Chapter 9: Slope, Survey, Scaling, and Boundary Defects

Section A — Steep Slopes (Significance & Misclassification)

Section B — Inadequate Site Plan & Partial Boundary Verification (No Stamped Survey of Record)

Figure A1: Poverty Flats Site Plan showing proposed location of cultivation sites in relation to ridge lines and property boundary. Note: None of the cultivation sites are on the top of the ridge lines as claimed in the MND.

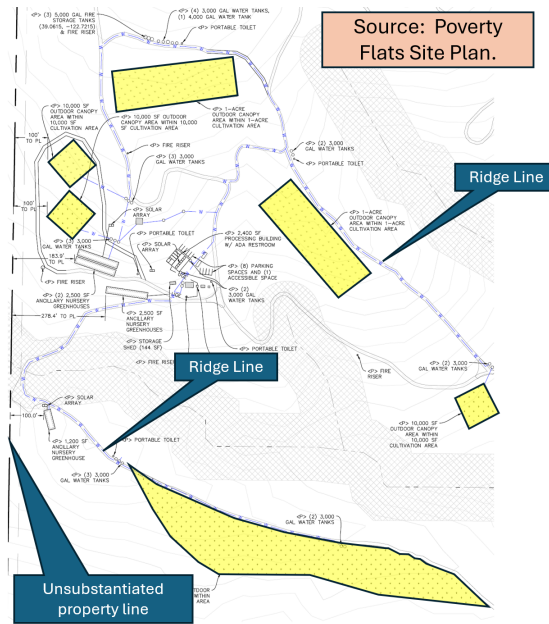
1. **The record admits steep terrain—and the site plan’s own pad/road placements contradict the “flat ridgetop” claim..**

The IS/MND reports an average slope of ~39.5%, and the Property Management Plan describes southern-aspect sloping montane topography—both incompatible with a “flat ridgetop” characterization [A4][A5]. In addition, the site plan locates multiple cultivation pads, access roads, and fencing lines along south- and southwest-facing hillslopes below the ridgeline, with contour spacing that reflects steep grade bands (e.g., 30–50% and greater) rather than level ridgetop benches (Figure A1, A2, A3, A4). Several features would require cut/fill and slope-length breaks to achieve workable grades, which further confirms the on-slope siting. Taken together, the file’s own drawings place project elements on steep slopes, directly contradicting the narrative assertion that cultivation areas are “flat, ridgetop areas” and triggering the need for slope-responsive analysis under CEQA. [A11][A12][A4][A5] [A6]

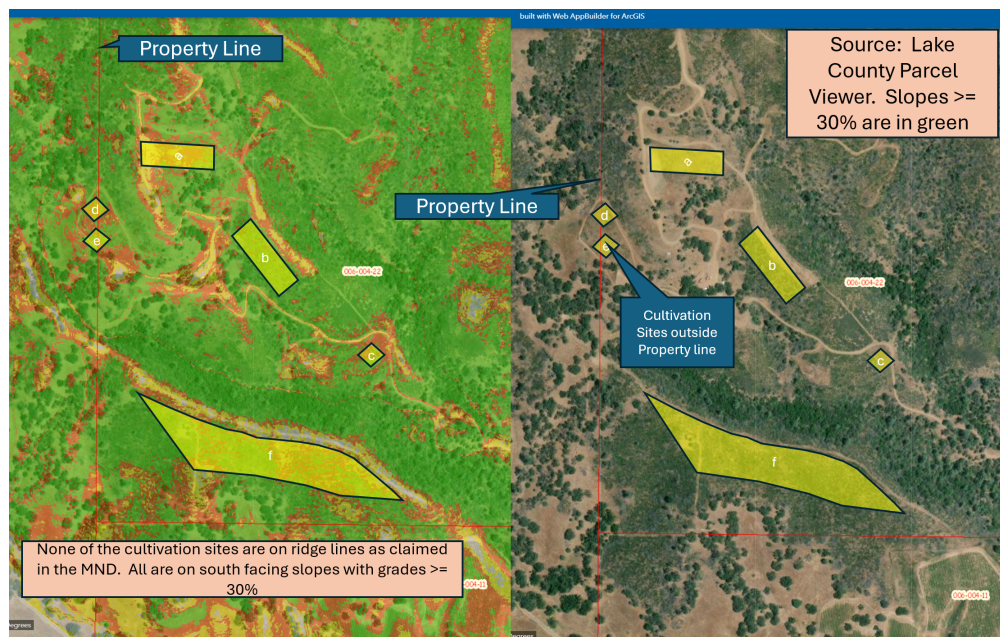
6. Parcel-viewer evidence indicates two cultivation sites extend beyond the legal parcel boundary.

Viewer-based overlays indicate areas of close proximity to parcel lines and

potential encroachment for two cultivation sites (Figure A2, A3). Because the western boundary has reportedly been field-verified, uncertainty may be reduced along that edge, but there is no stamped survey of the remaining parcel boundaries or the disturbance polygons. Accordingly, encroachment cannot be confirmed or ruled out without a complete, stamped boundary (and topographic) survey. The County Surveyor has already instructed that Parcel Viewer lines are not acceptable for legal parcel boundaries or setbacks and that a professional survey must control setback measurements. Separately, BLM has required a professional survey to confirm the project's position relative to federal lands. Until a stamped survey demonstrates that each cultivation polygon and associated grading/fencing lies entirely within the legal parcel and outside all required buffers, any "less-than-significant" finding that depends on boundary geometry remains speculative under CEQA.

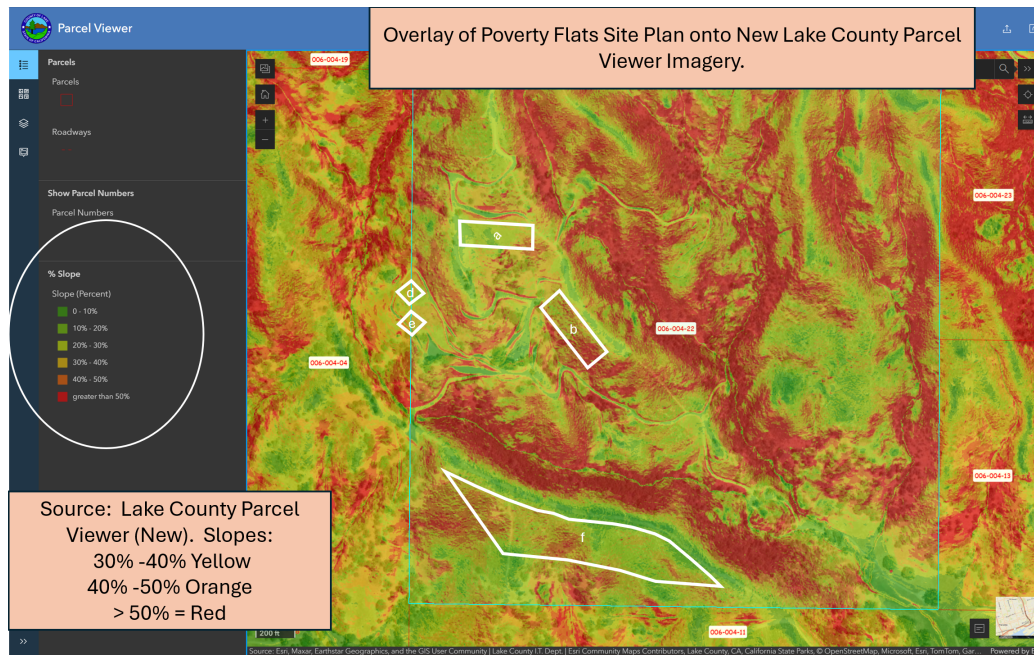
3. $\geq 50\%$ slopes foreclose Tier-2 enrollment and require denial or an EIR.

The State Water Board's Cannabis Policy prohibits cannabis cultivation or cultivation-related disturbance on slopes $\geq 50\%$ unless a Regional Water Board issues site-specific WDRs [A16]. The Statewide Cannabis General Order (WQ 2023-0102-DWQ) treats $>30\%$ and $<50\%$ as Moderate Risk but does not allow Tier-2 enrollment where any portion of the disturbed area is $\geq 50\%$ [A15][A17]. The record now shows disturbed polygons intersecting $\geq 50\%$ grades (Figure A3). Because the IS/MND neither discloses nor analyzes a site-specific WDR path—and CEQA forbids post-approval fixes—the Tier-2 premise fails as a matter of law. The appropriate action is to deny the Major Use Permit. If the applicant wishes to pursue any alternative regulatory pathway (including site-specific WDRs or any relocated design to address $\geq 50\%$ slopes), that would be a new or substantially revised project that must proceed by EIR, not by this IS/MND. [A15][A16][A17]

Figure A4: USDA soil map survey of Poverty Flats approximate cultivation locations. Note: All locations exceed 30% grade and are on soils with “high to severe” erosion risk.

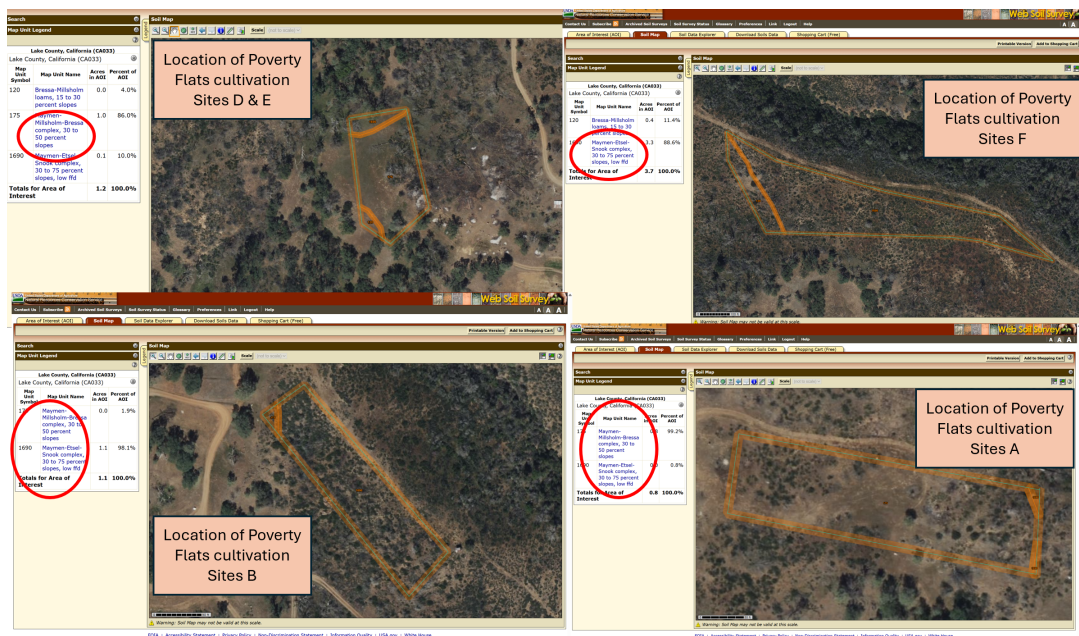
4. Mapped evidence corroborates steep-slope hazards.

Site-plan overlays and USDA soil mapping place cultivation polygons across 30–50% and 50–75% slopes, on units the Clear Lake Nutrient TMDL identifies as severe erosion hazard (e.g., Maymen–Etsel–Snook 30–75% (severe); Maymen–Millsholm–Bressa 30–50% (severe)), confirming high potential for sediment delivery absent robust controls [A14] (Figure A4).
